TOWN OF WATERTOWN

**Contract Number: 614.8
Chiller Replacement
Watertown Town Hall
149 Main Street,
Watertown, MA 02472**

ADDENDUM NO. 1
AUGUST 11, 2021

Project: WATERTOWN TOWN HALL, MA		Sketch No.: SKH-01	
Title: CHEMICAL SHOT FEEDER SKETCH			
Date: 08/09/21	Scale: As Noted	Project No.: 17055	
Drawn By: CW	Rev. No.: -	Dwg. Ref.: -

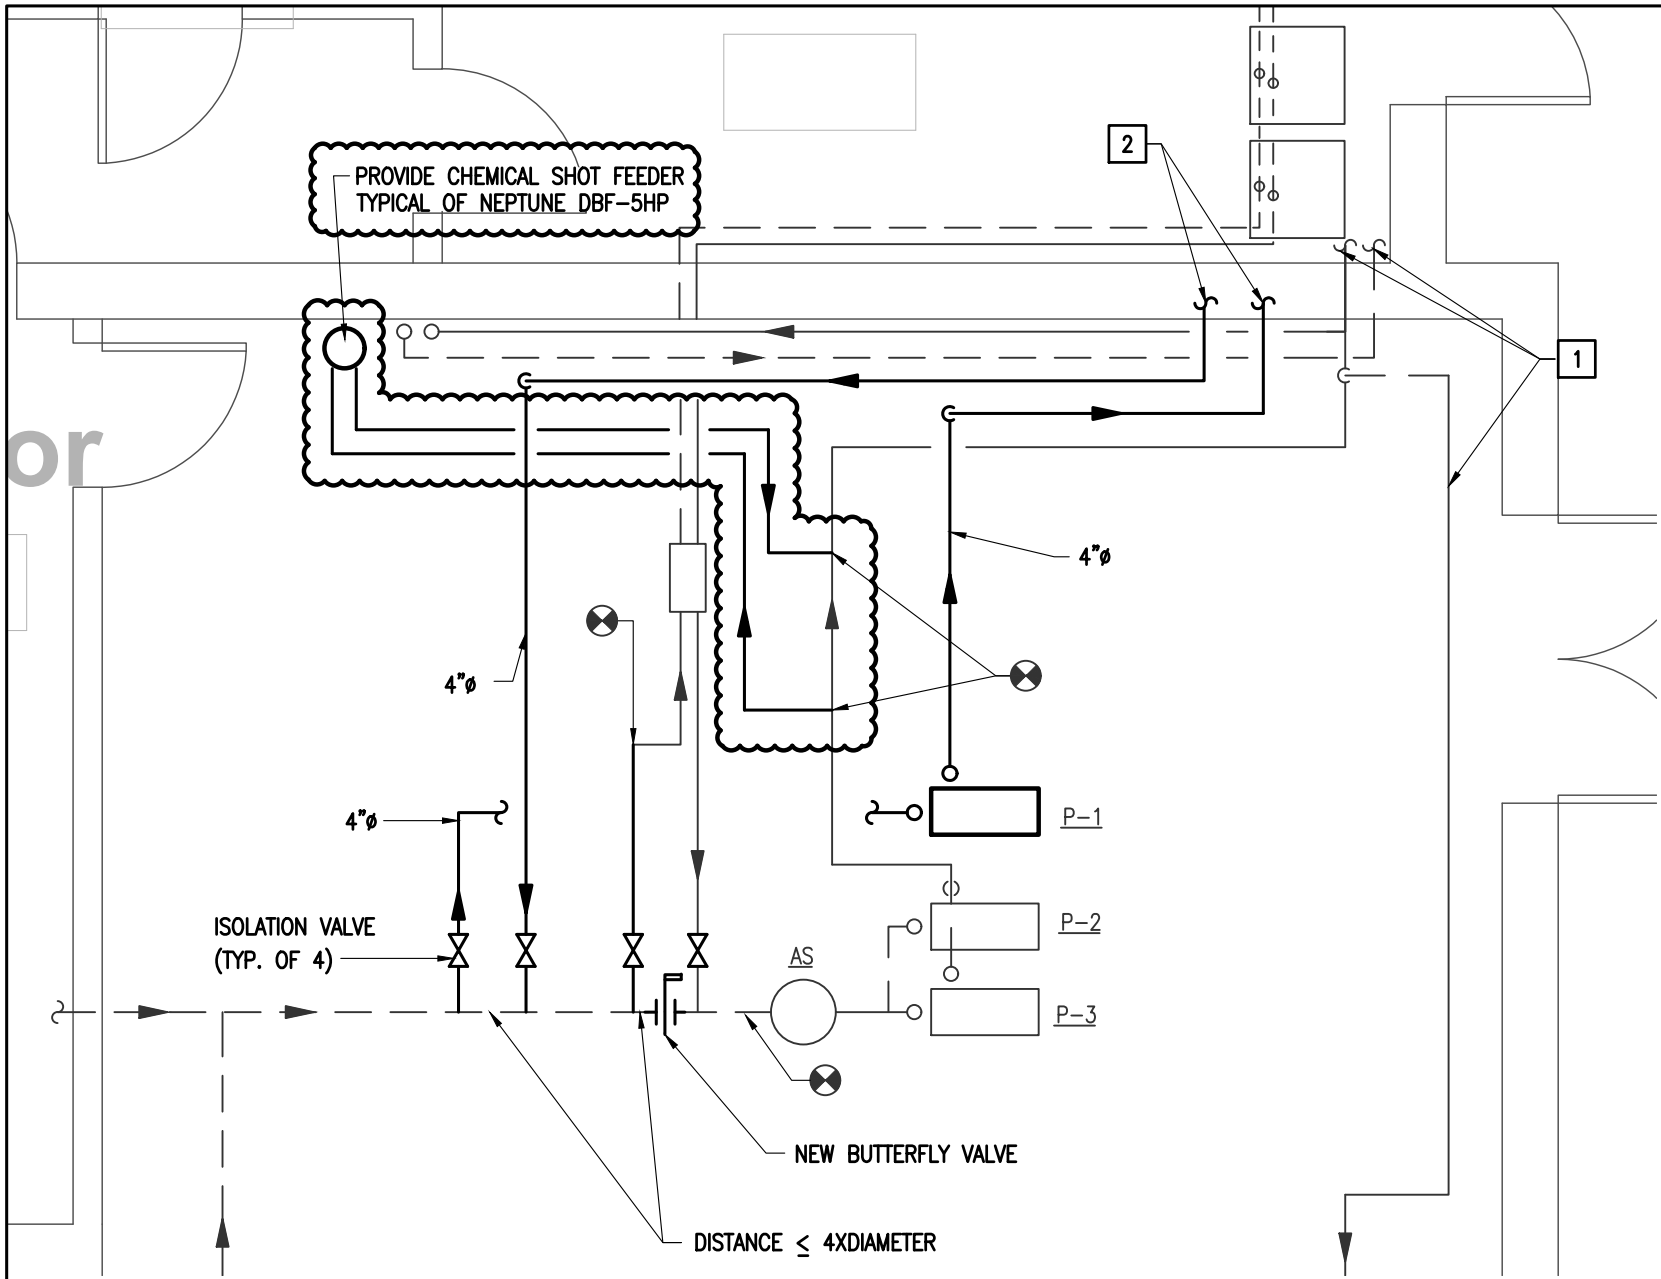
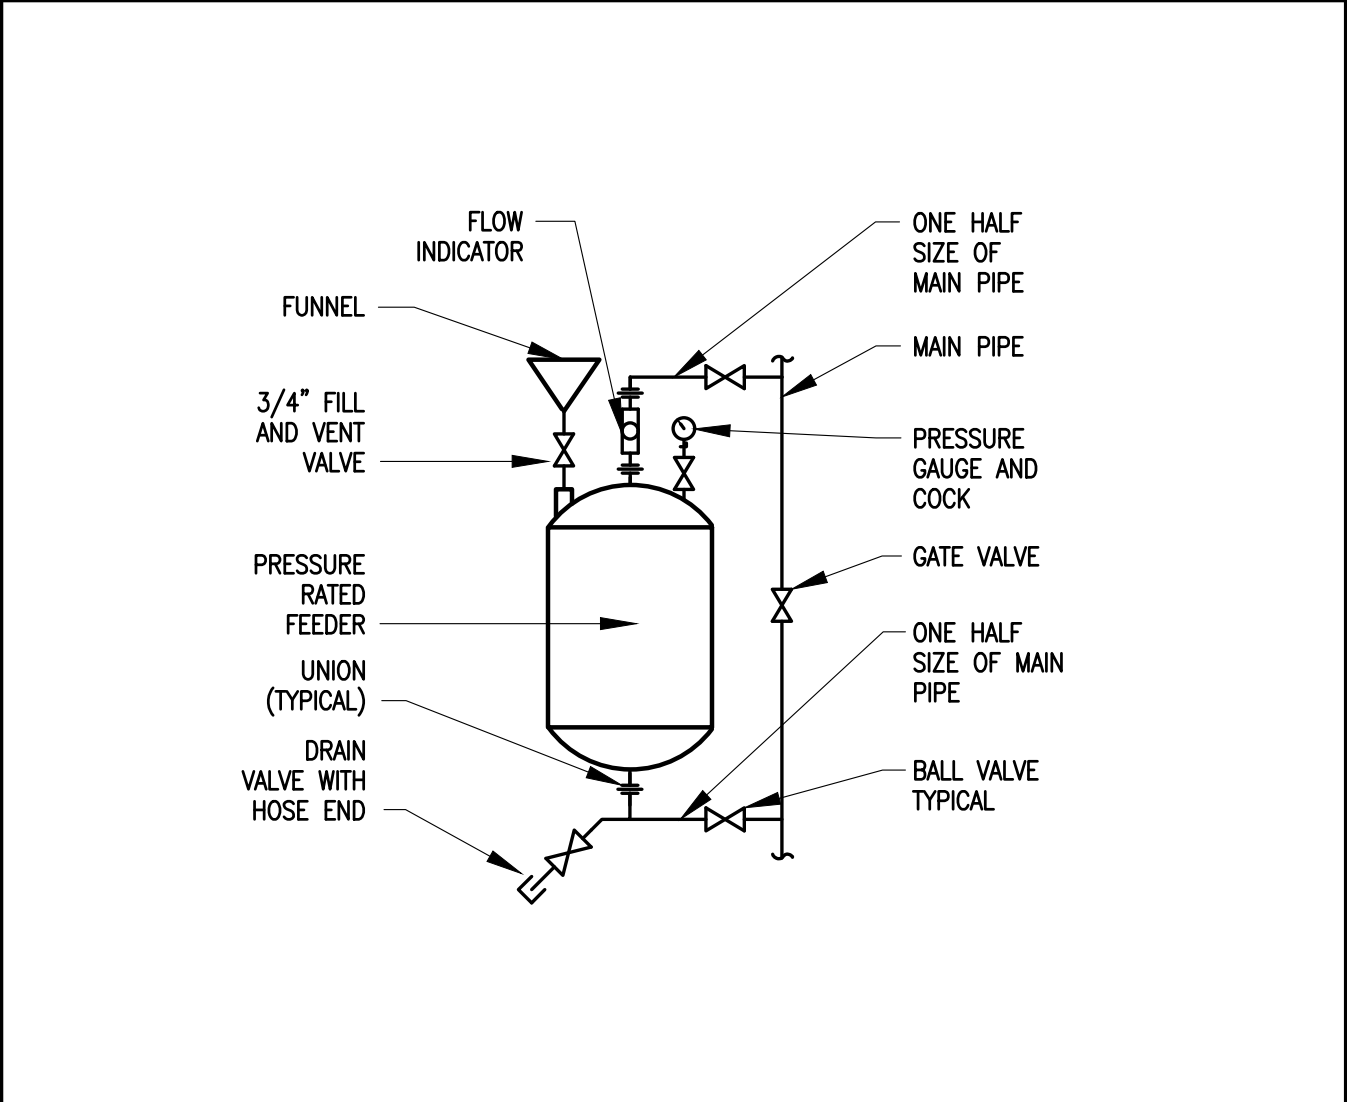
- 3.1. ADD the attached SKH-01 Chemical Shot Feeder sketch dated 08/09/21.

- Q6: *In the spec paragraph 2.16 Water Treatment it calls for a chemical shot feeder and a two (2) station corrosion coupon rack. There is nothing on the plans that shows how and where to install this equipment. Are we to provide this equipment? If so, please send a sketch on where to install it.*

- A6: See attached enclosed SKH-01 Chemical Shot Feeder for integration to the chiller system. The coupon rack shall be omitted from the scope of work.

E-1.0

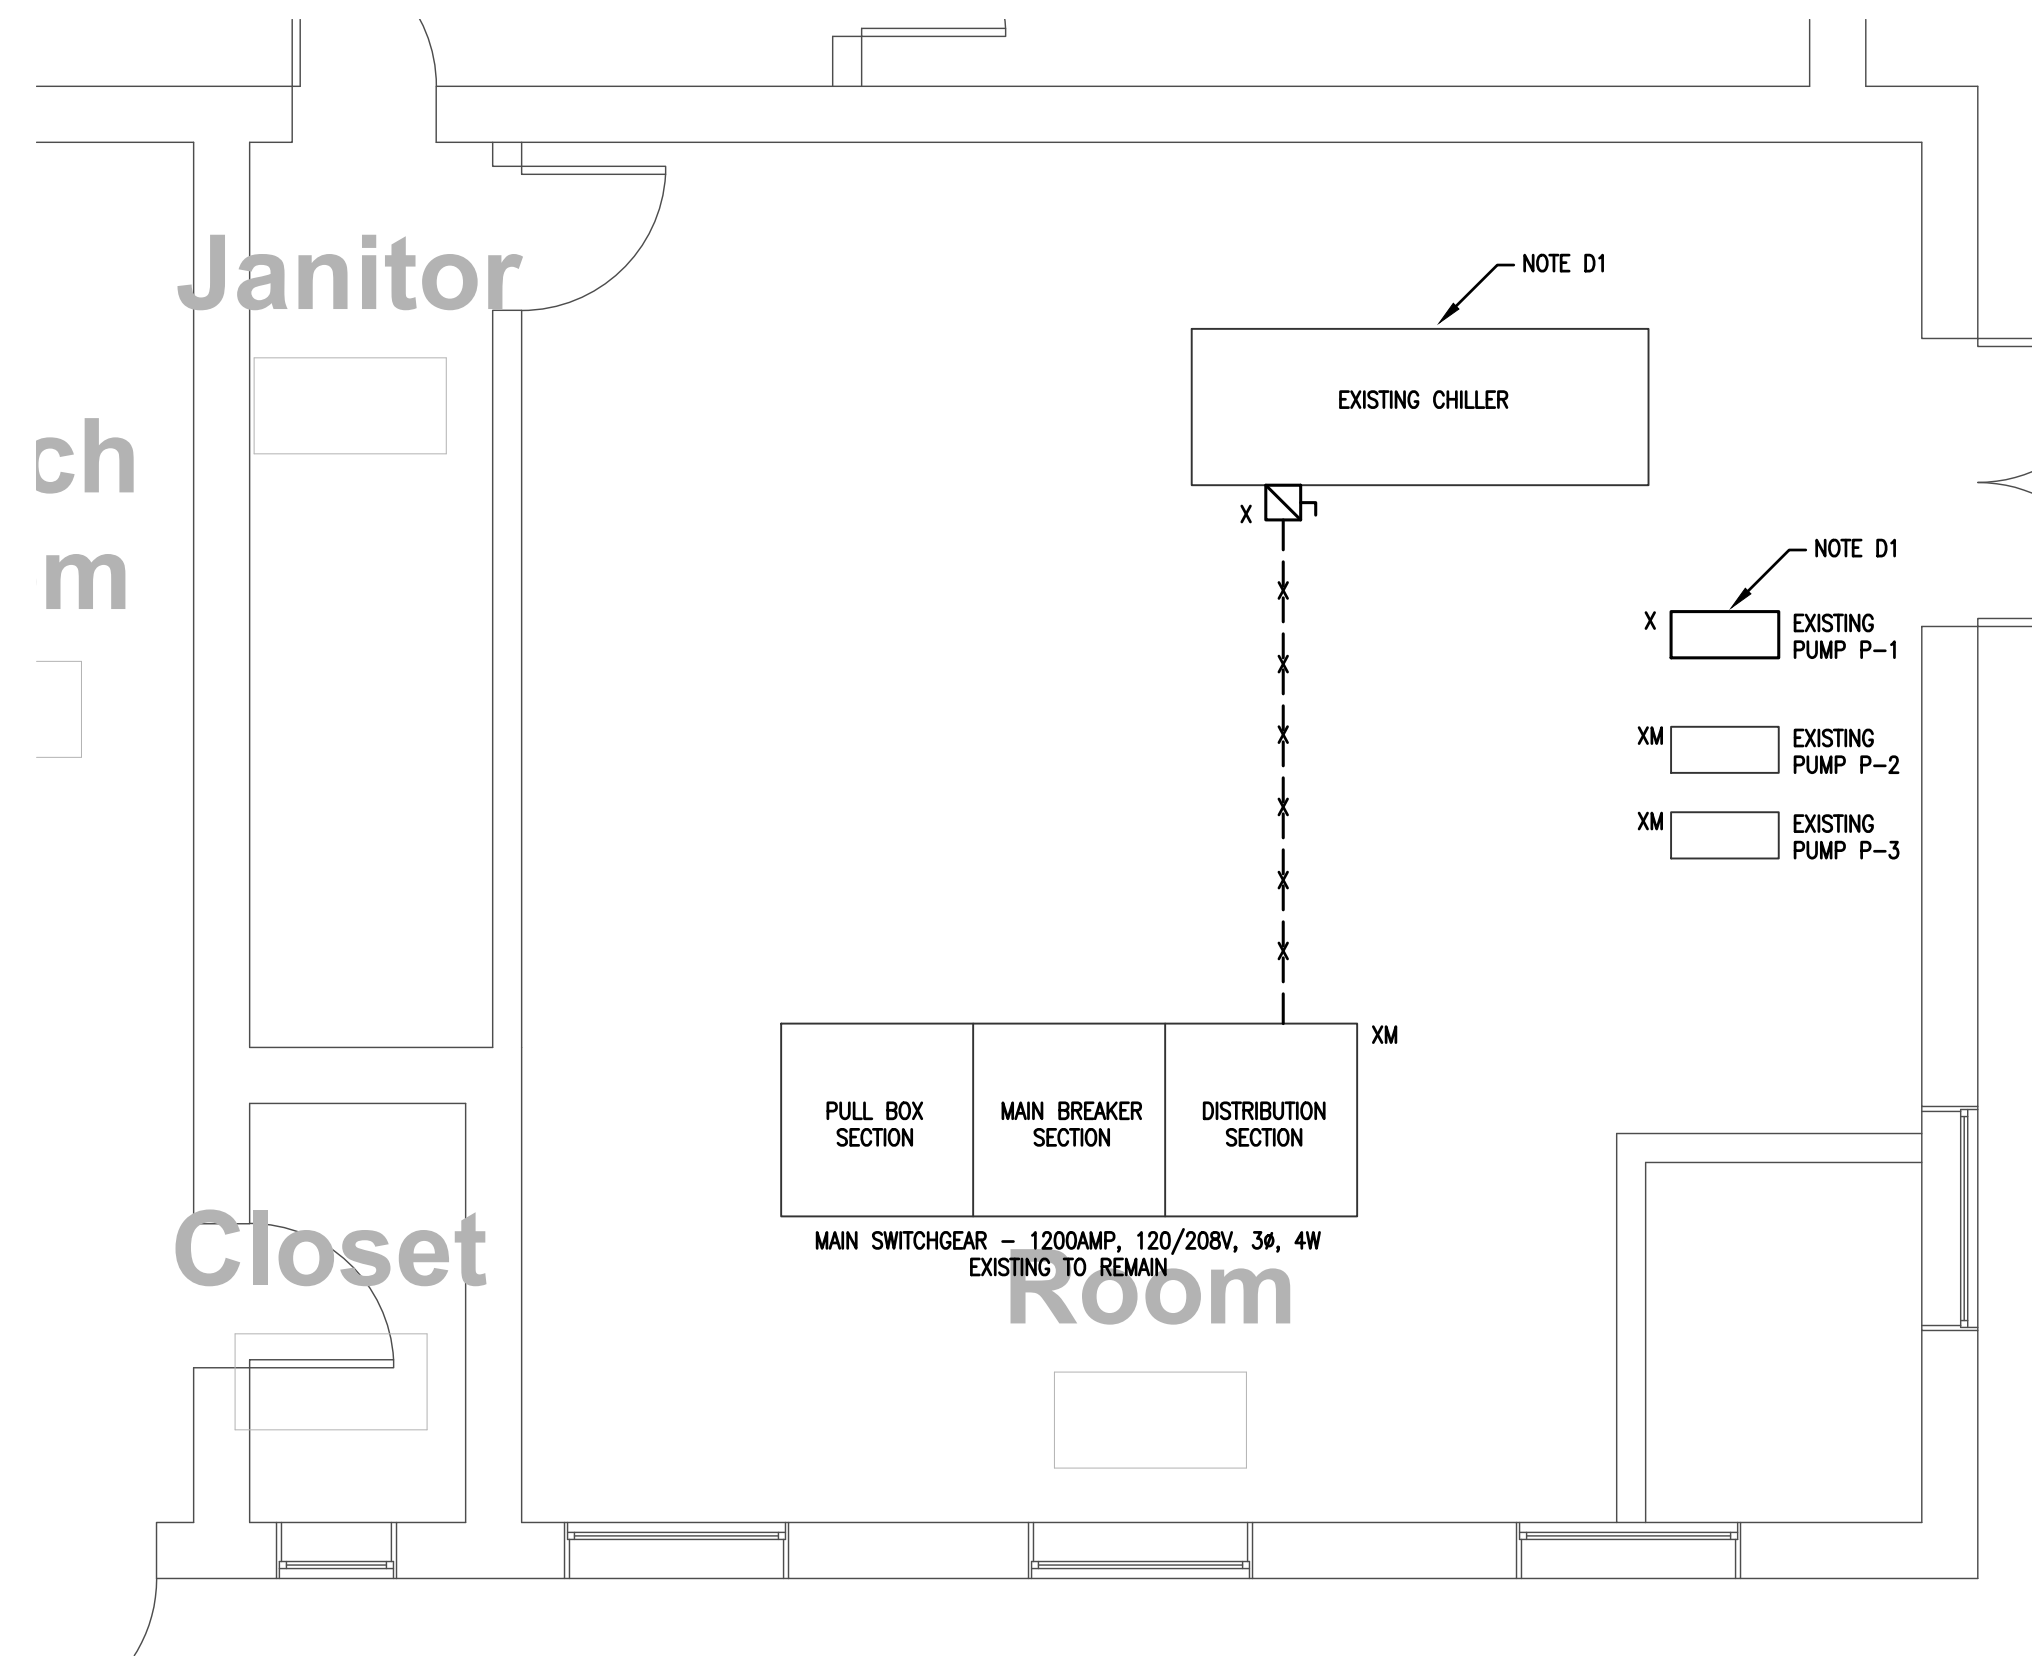
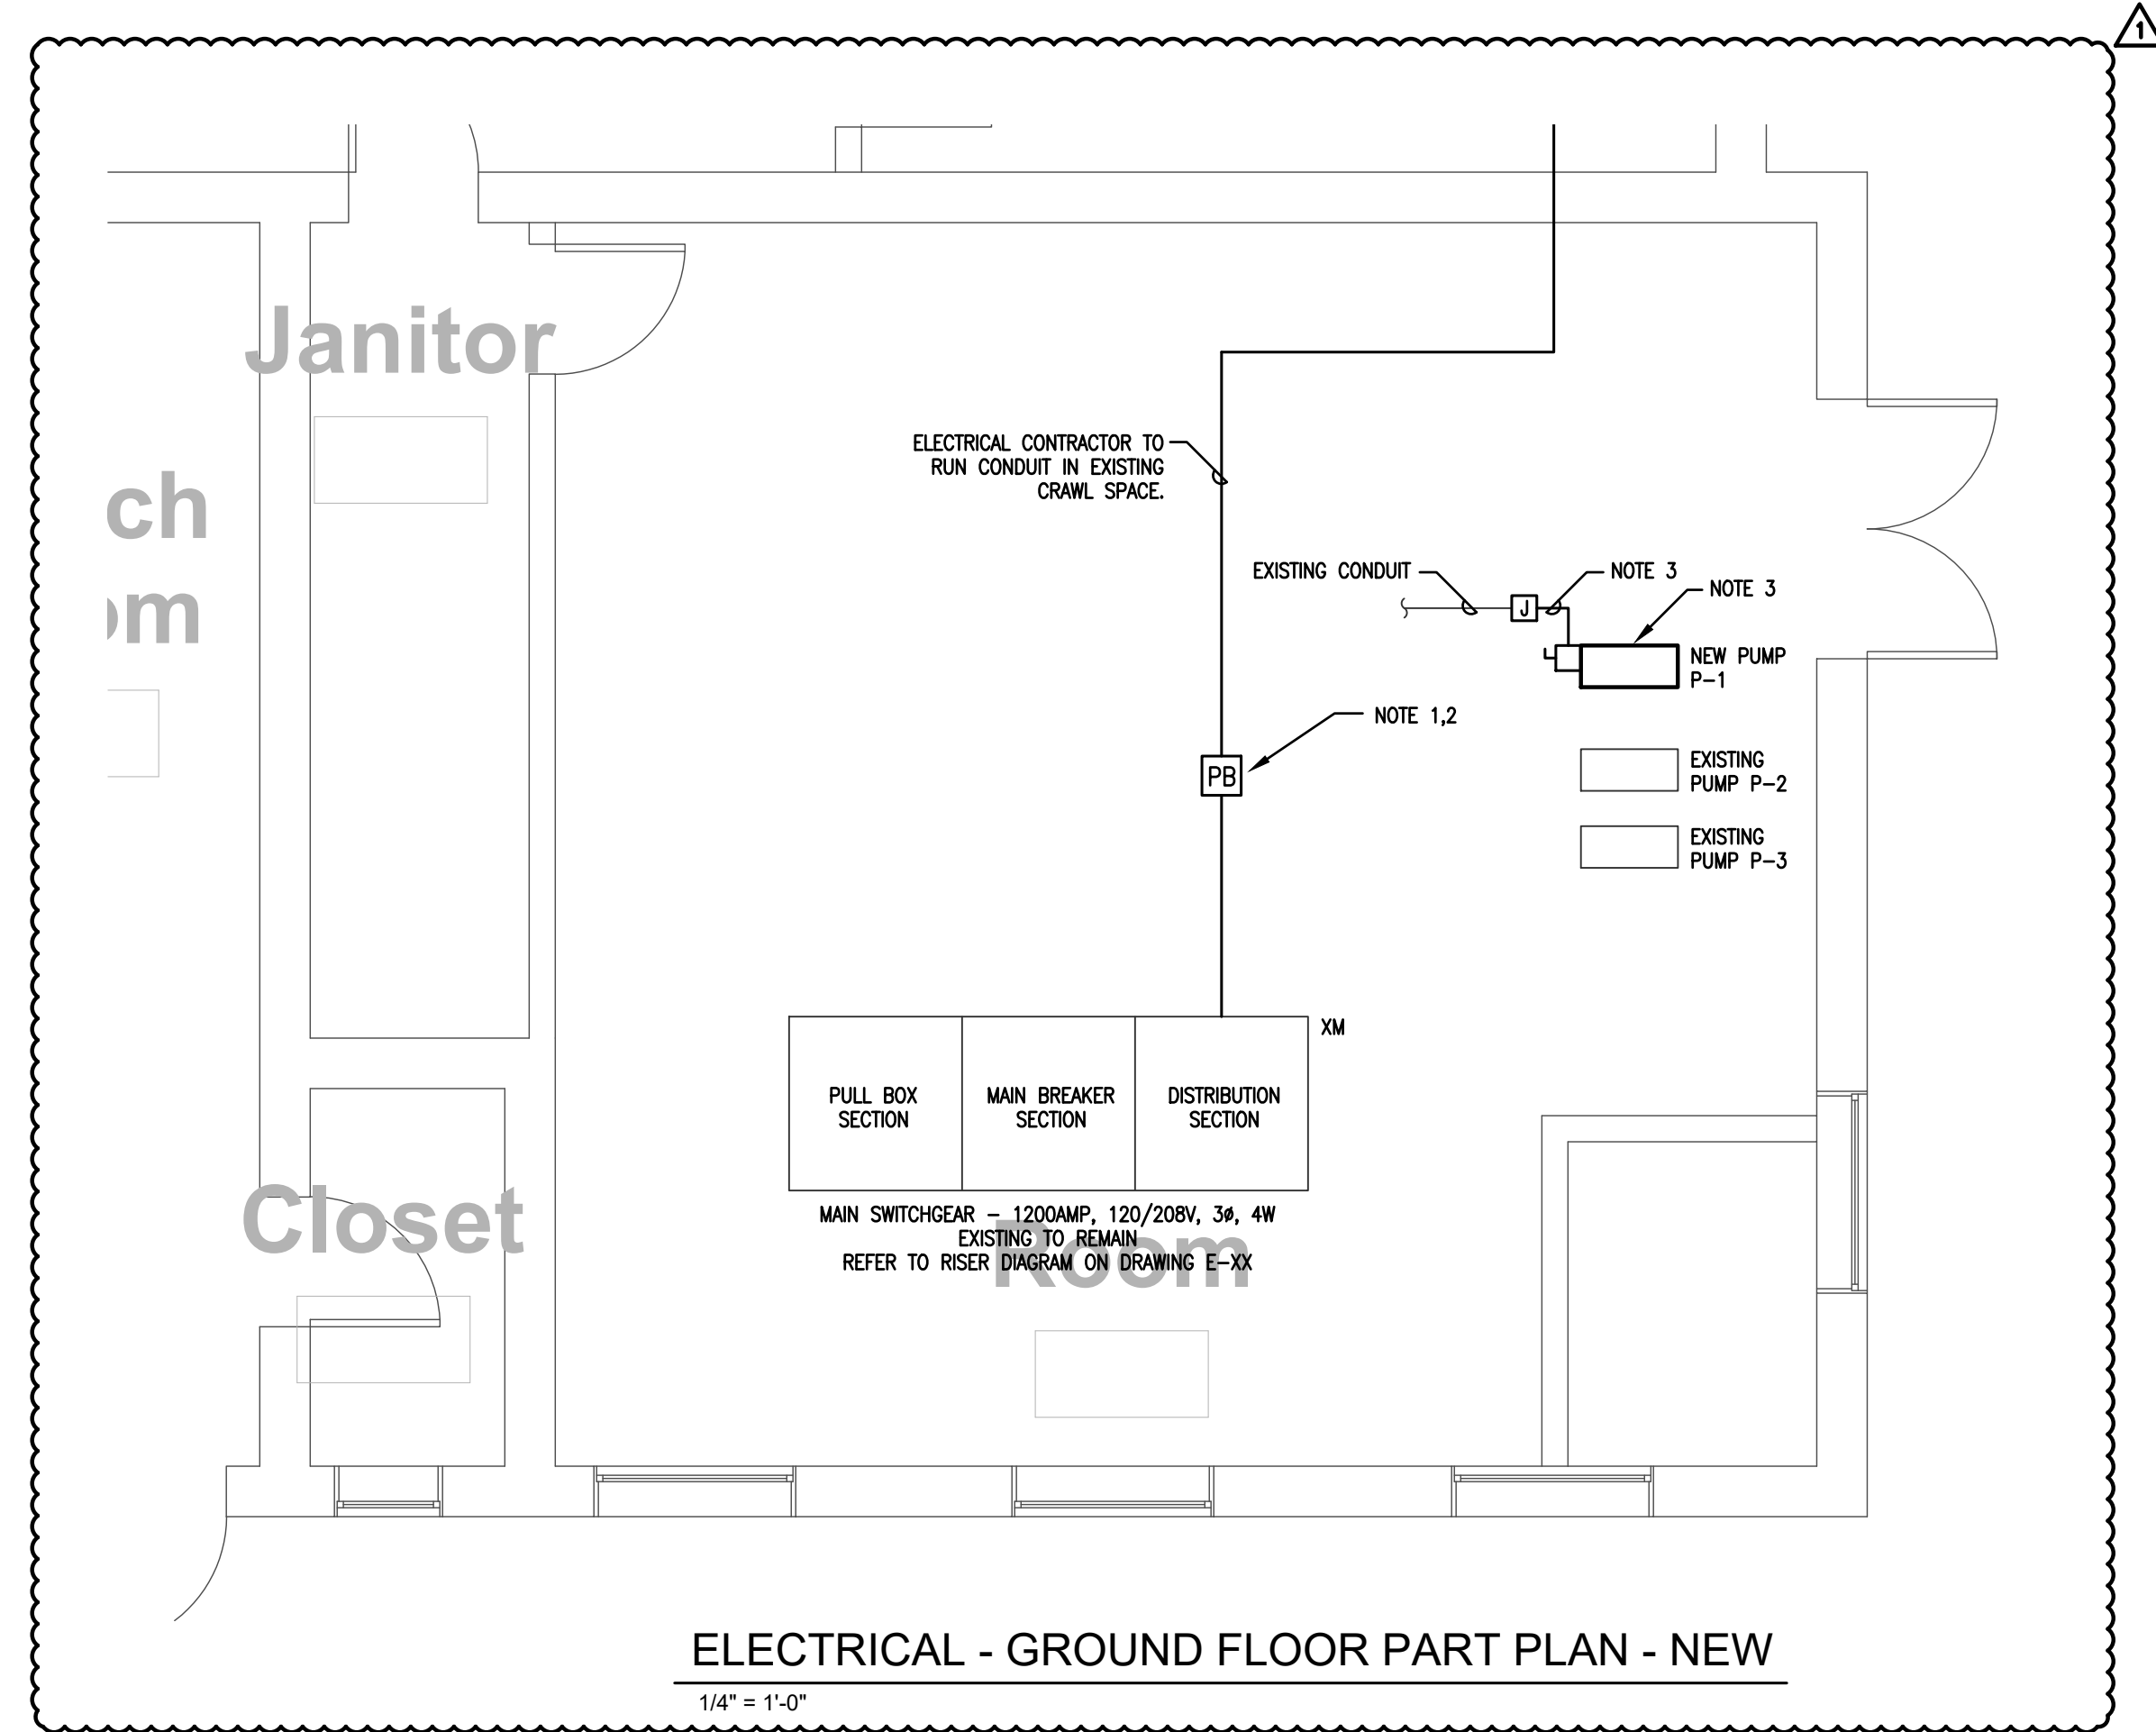
- 5.1. REPLACE Electrical Sheet E1.0 with the attached Electrical Sheet E1.0 Revision 1 dated 8/6/21.
